HUALAPAI INDIAN NATION  
PEACH SPRINGS, ARIZONA  
IFB NO. 03-2023

Pre-Bid Questions and Answers on Invitation for Bids from Residential Building Contractors for  
Renovation of Single-Family Home in Peach Springs, AZ

**ADDENDUM NO. 1**

**Response to Questions**

**A-1**

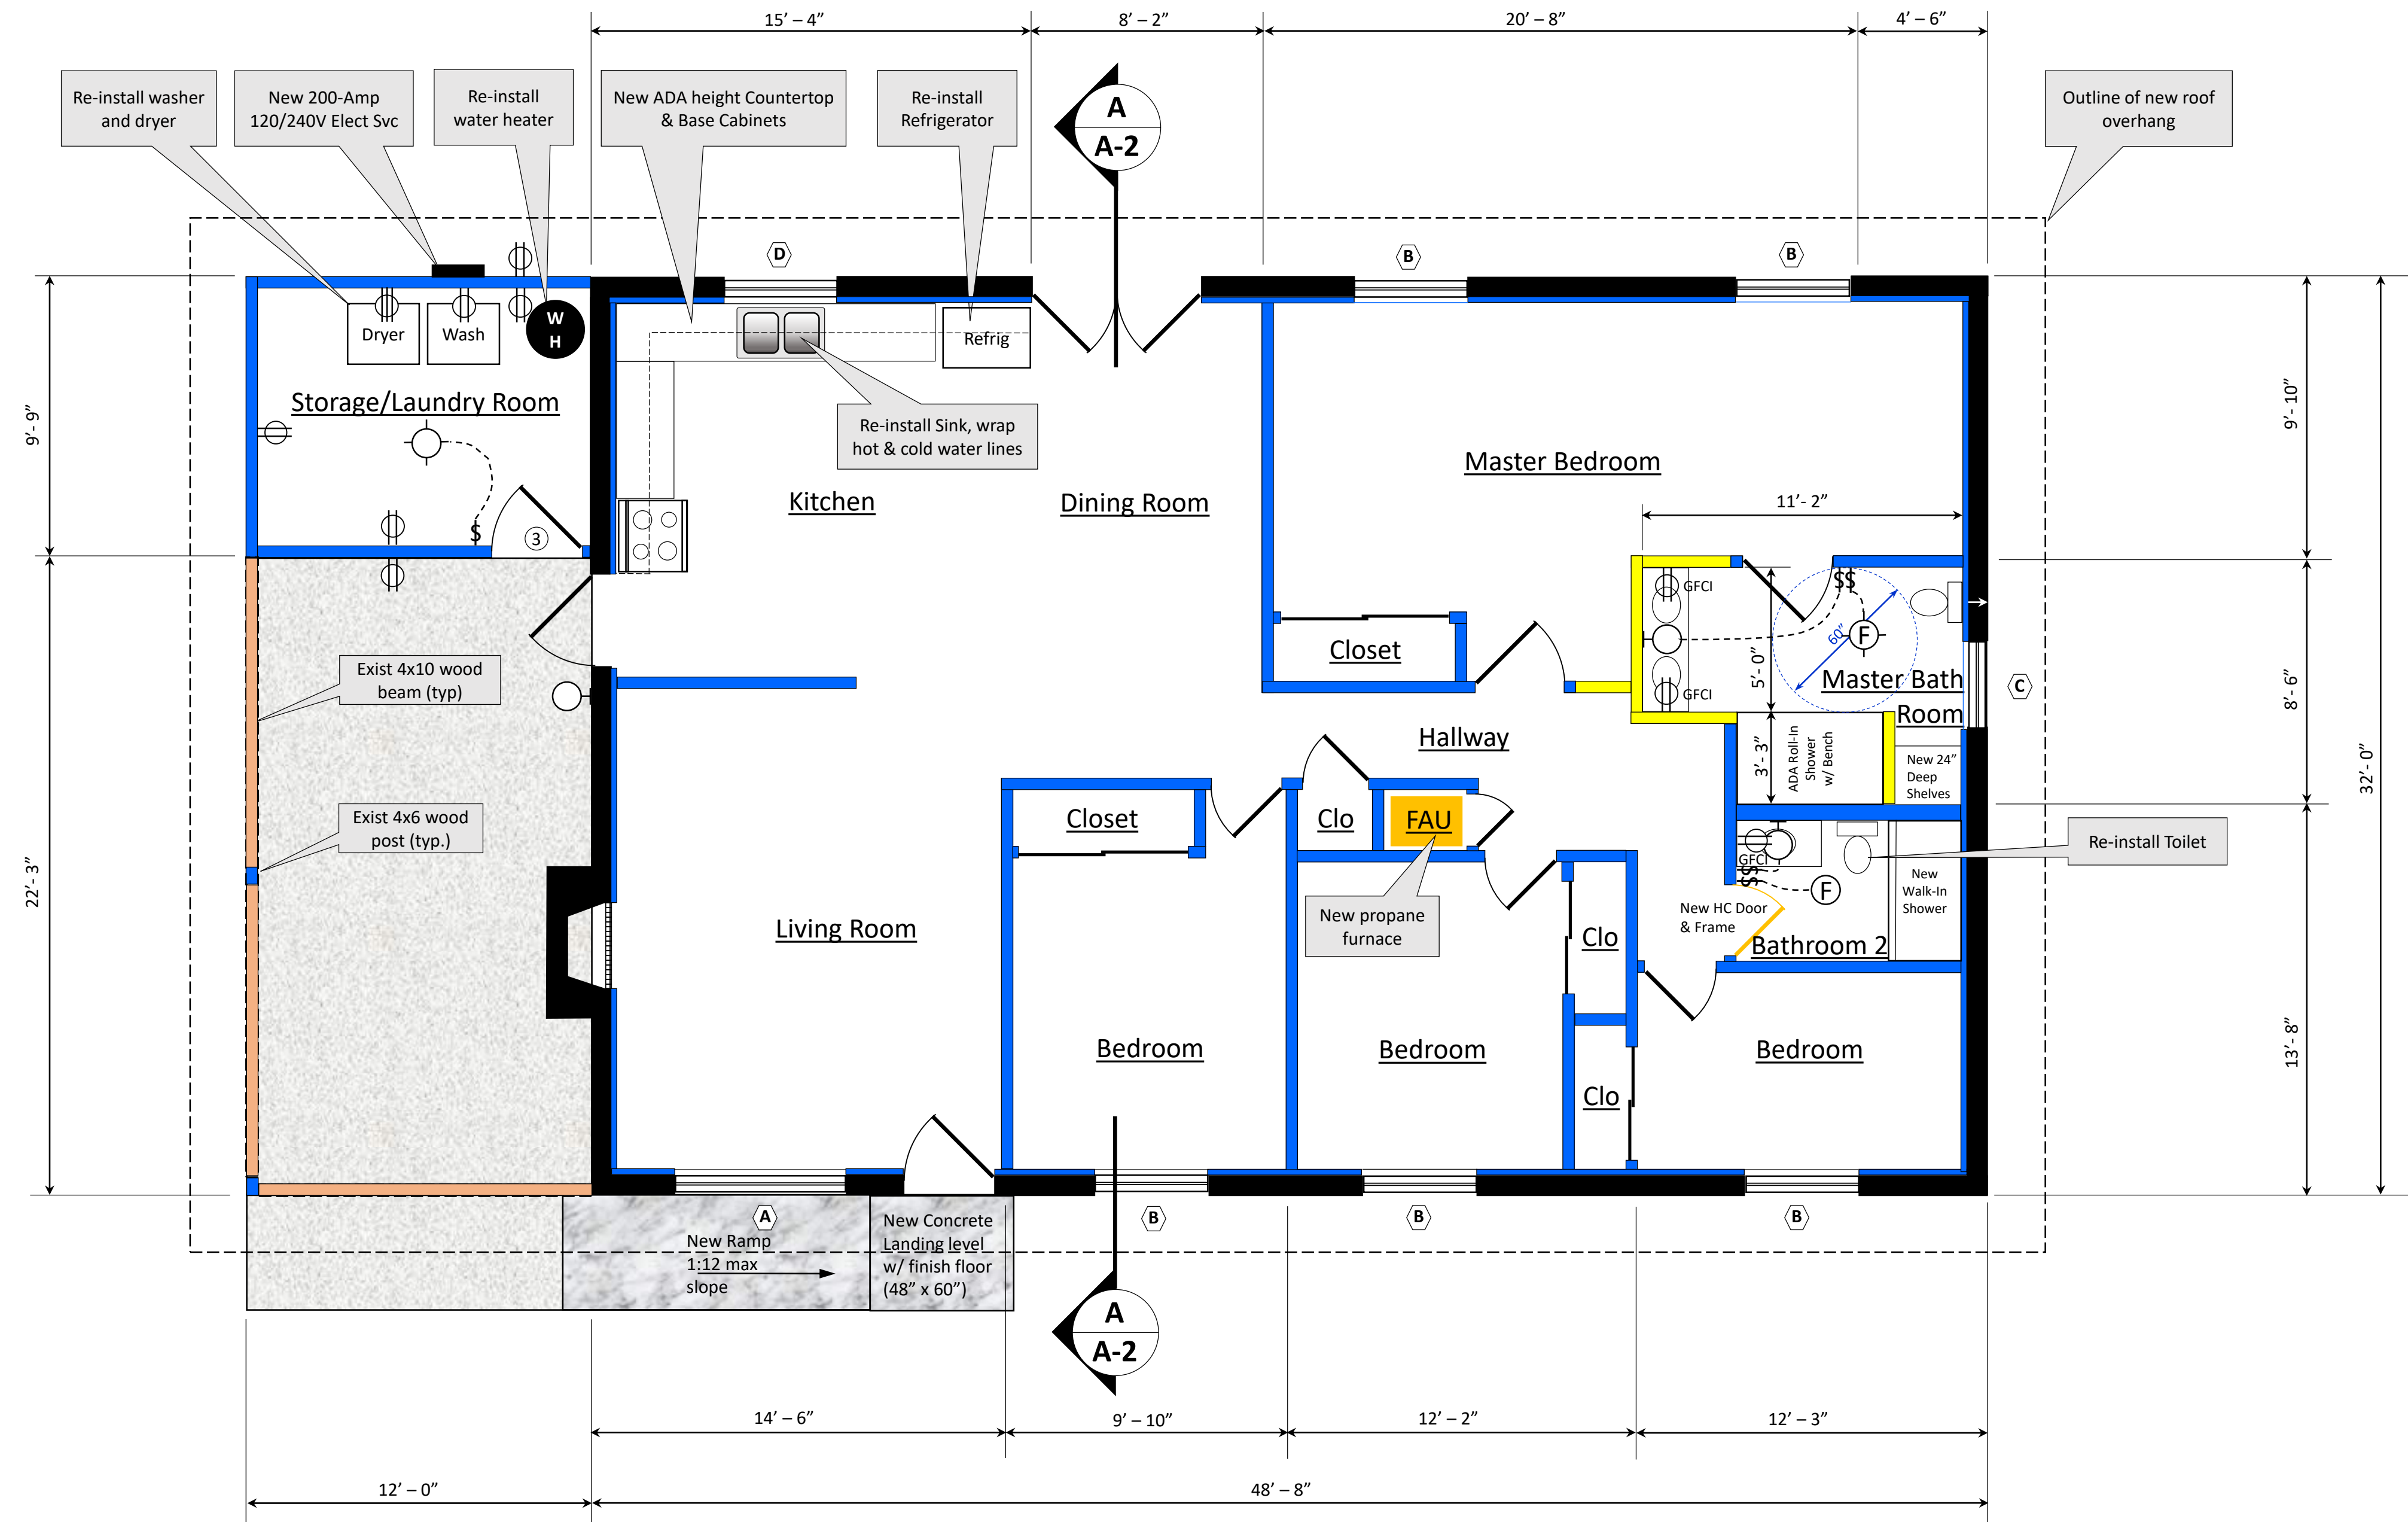
10. *Should we extend the length of the ADA ramp to the front door to remove cracks in the existing concrete sidewalk? Yes, see attached floor plan.*

**A-2**

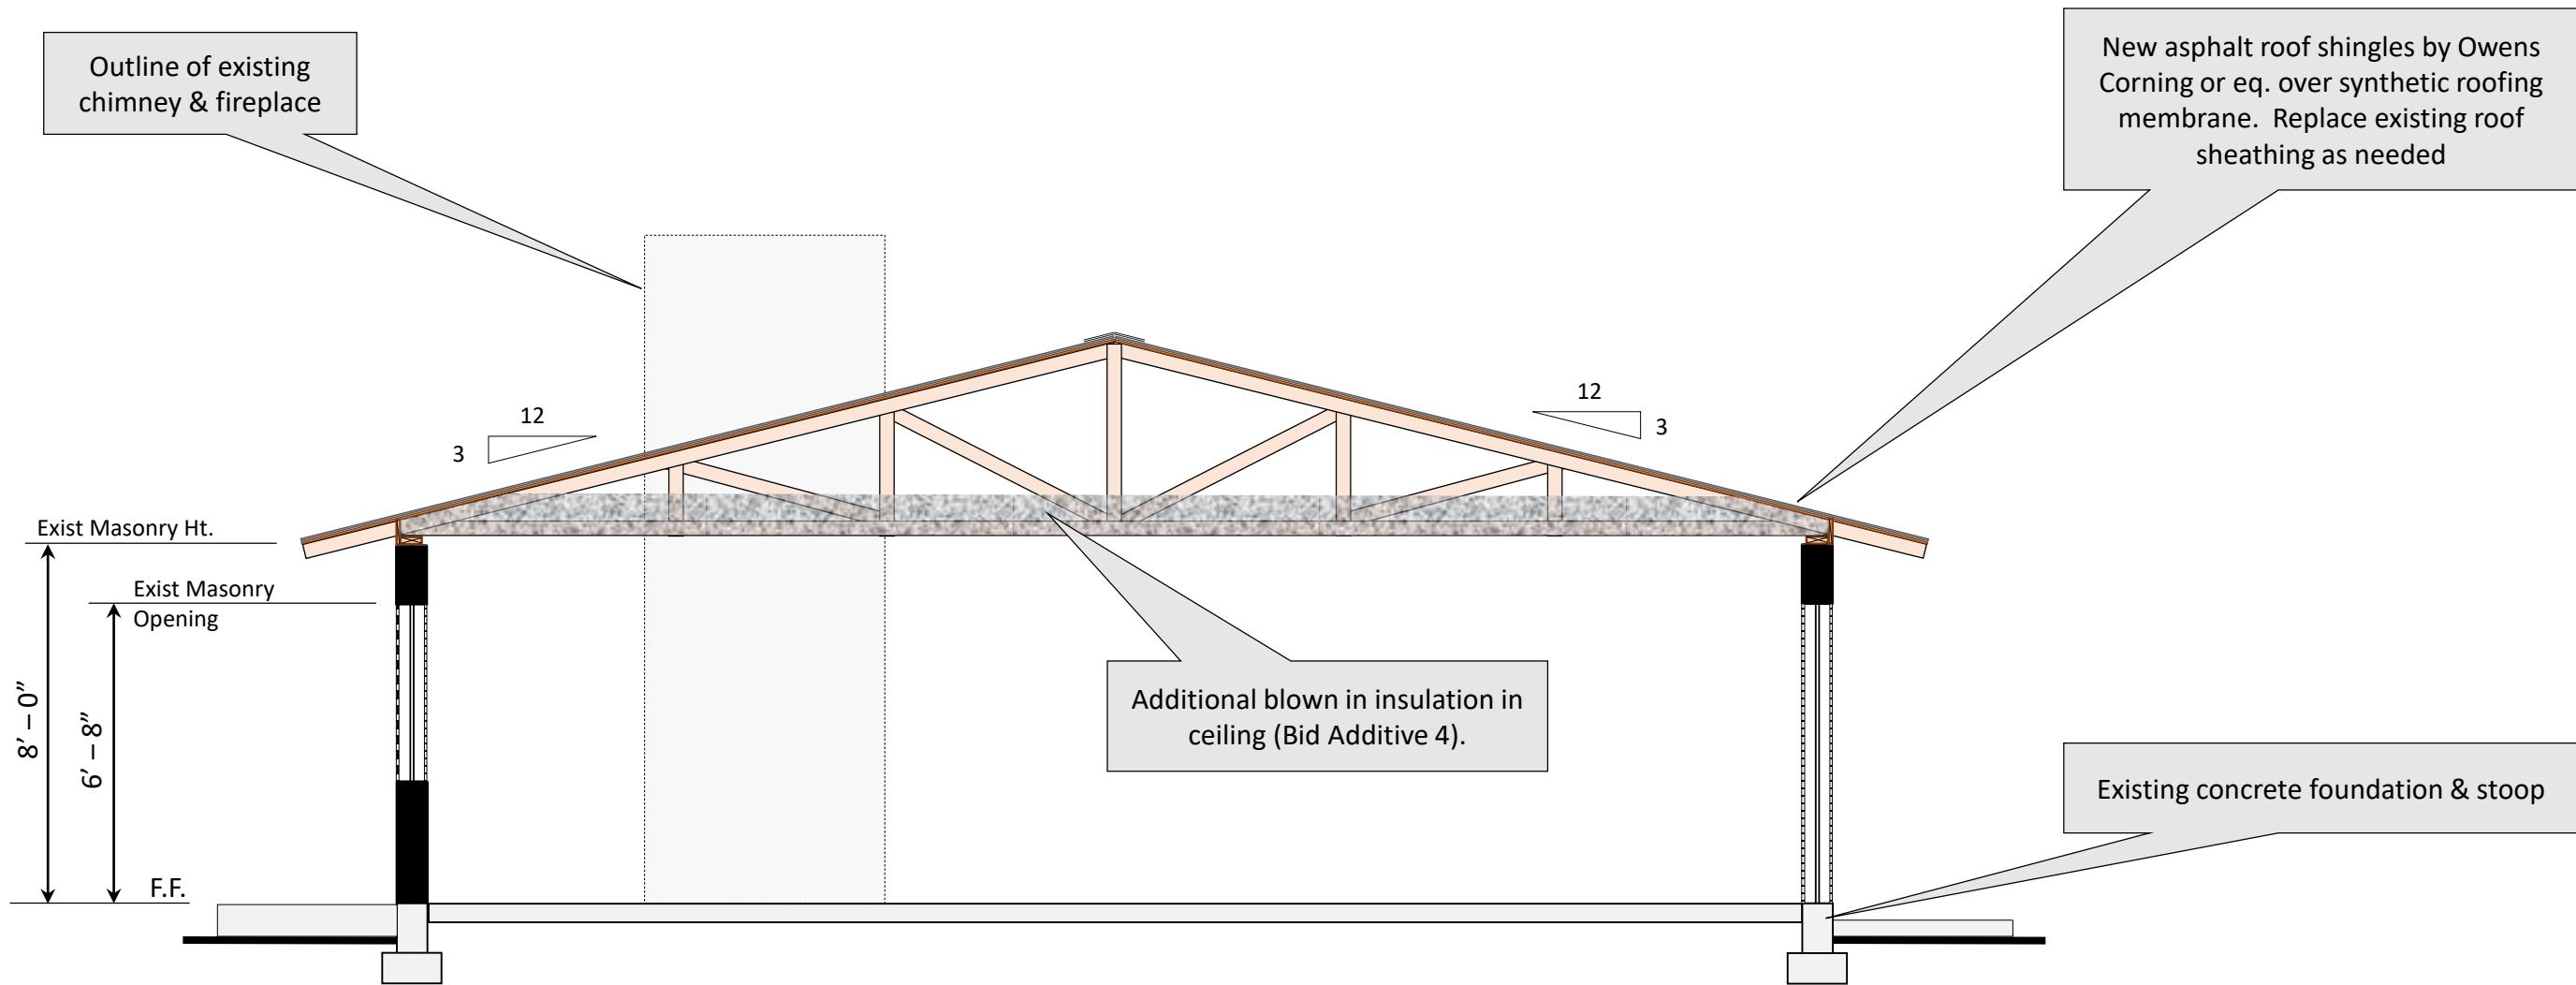
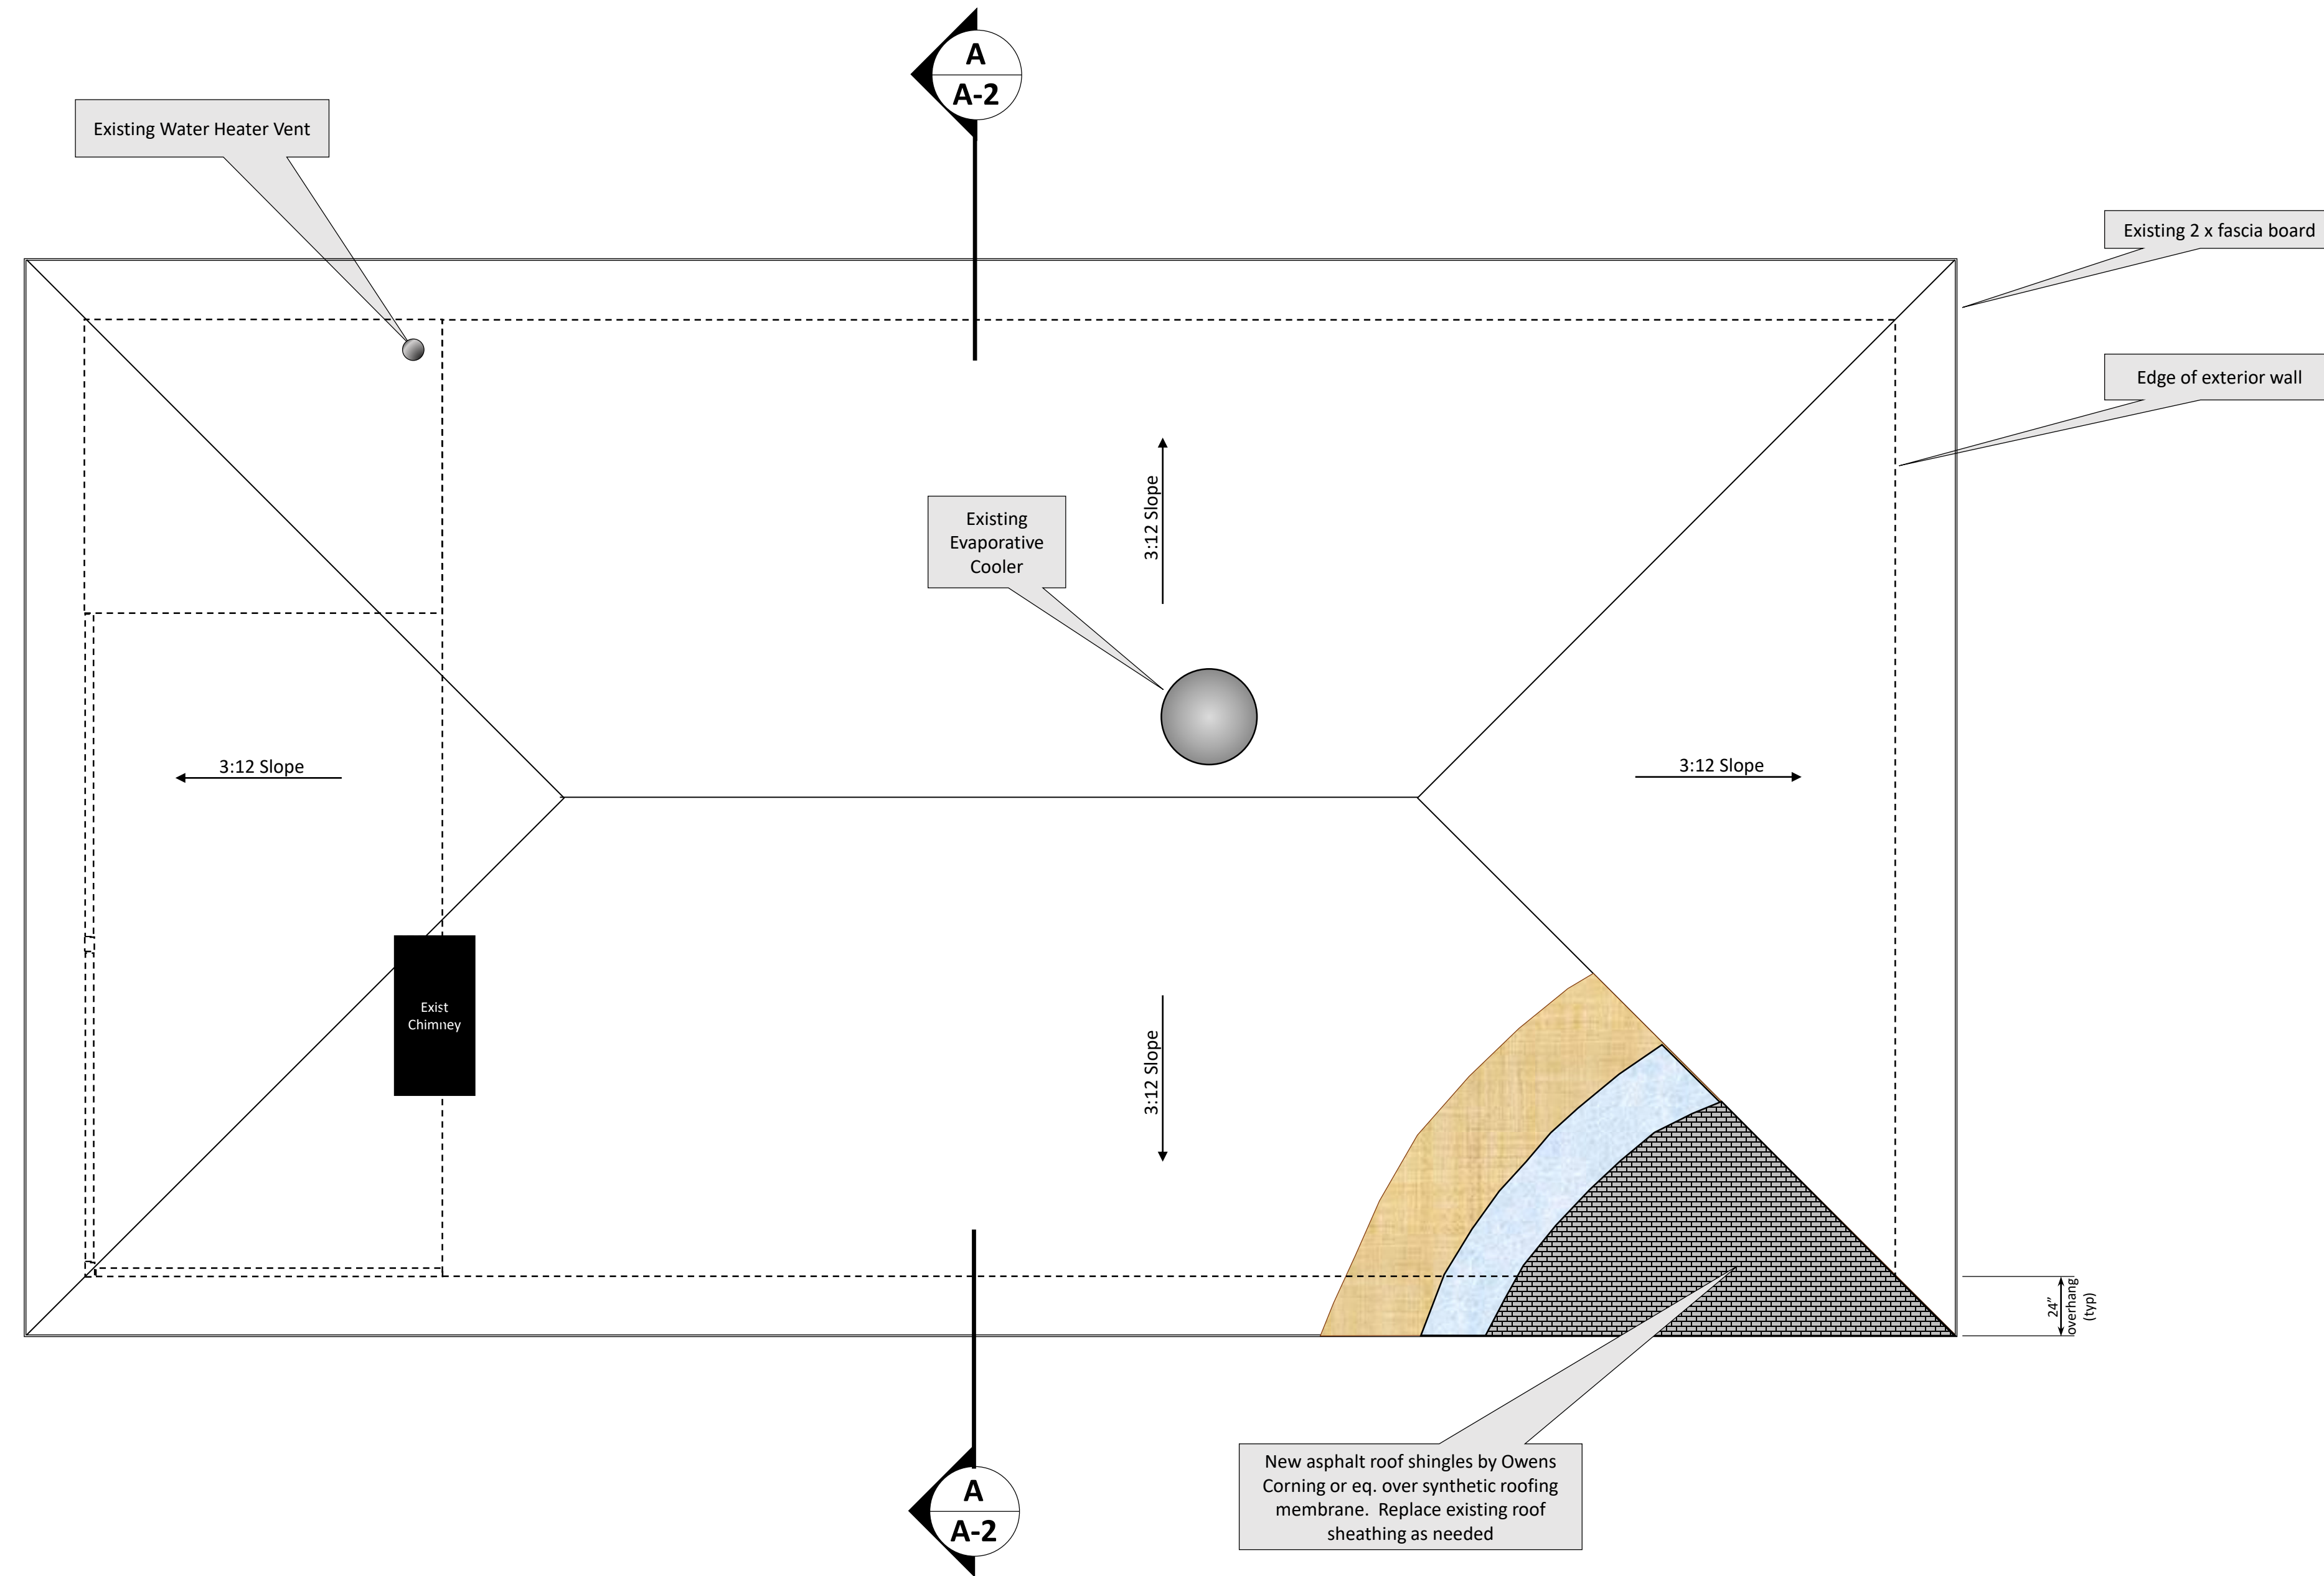
8. *Given previous roof leaks around the chimney and southern part of roof over the bathrooms we recommend re-sheathing in these areas. Yes, estimate replacing 15 to 20 4'x8' sheets of roof sheathing.*
